ACCESSIBILITY ASSESSMENT REPORT · SAMPLE, FOR ILLUSTRATION ONLY

Town of Clearwater

Clearwater Public Library
1204 Main Street, Clearwater AB T0M 0M0

Carl Christie, RHFAC Professional

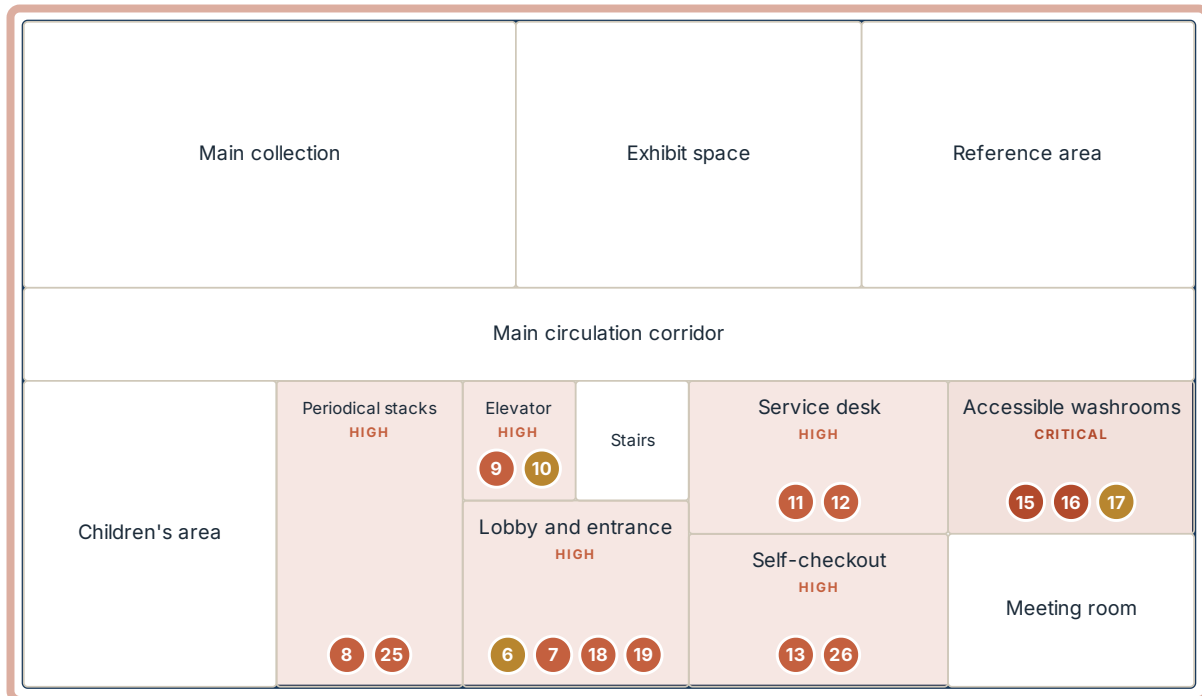
Finding 23 — no visual fire alarm coverage on the main floor. A whole-floor failure, so it carries no single pin. Costed once, with the upper floor, at \$8,500–\$14,000.
